Access Compliance Report

Public Rights-of-Way (Curb Ramps)

Intersection ID: 15174	Main Street: DILWORTH_RD_WEST	Cross Street: IDEAL_WY	Location: NE
ADA ID: E43CB11C3A0A	Ramp Type: Directional1	Initial Pass/Fail: Fail	Overall Compliance: No
		Severity Score: 25

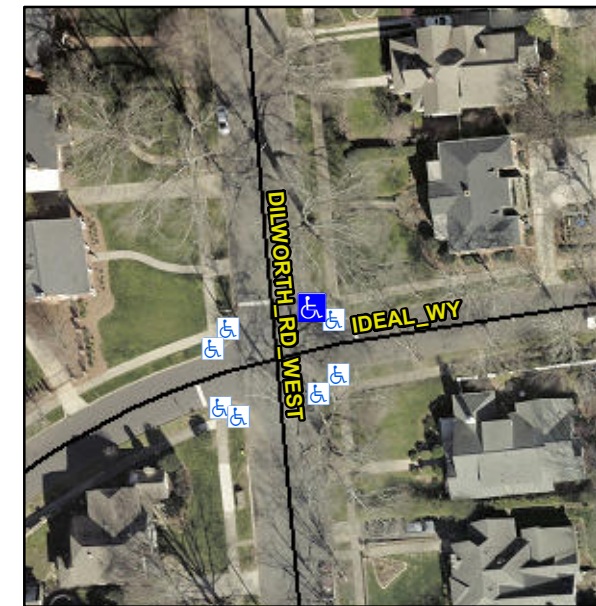
Compliance	Description	Data	Compliance	Description	Data
N/A	Ramp Length (in)	110.0	N/A	Grade Break?	N/A
Yes	Ramp Width (in)	48.0	N/A	Grade Break Slope (%)	0.0
Yes	Ramp Slope (%)	5.8	N/A	Grade Break XSlope (%)	0.0
No	Ramp XSlope (%)	7.6			
N/A	Flare Type LT	N/A	N/A	Flare Type RT	N/A
N/A	Flare Slope LT (%)	N/A	N/A	Flare Slope RT (%)	0.0
N/A	Flare Traversable LT?	N/A	N/A	Flare Traversable RT?	N/A
N/A	Landing Length (in)	0.0	N/A	DWS Provided?	N/A
N/A	Landing Width (in)	0.0	N/A	DWS Contrast?	N/A
N/A	Landing Slope (%)	0.0	N/A	DWS Length (in)	N/A
N/A	Landing X Slope (%)	0.0	N/A	DWS Full Width?	N/A
N/A	Landing Curb? (Y/N)	N/A	N/A	DWS Offset LT (in)	N/A
N/A	Shared Landing?	N/A	N/A	DWS Offset RT (in)	N/A
N/A	Gutter Ponding?	Yes	N/A	Gutter Slope (%)	N/A
N/A	Gutter Lip Ht (in)	0.0	N/A	Gutter X Slope (%)	N/A
N/A	Painted X Walk1?	No		Road Slope (%)	4.2
	X Walk 1 Direction	To SW		Road X Slope (%)	1.5
	X Walk 1 Width (in)	N/A		Clear Space?	N/A

Remove & Replace Entire Ramp.

R304.5.3
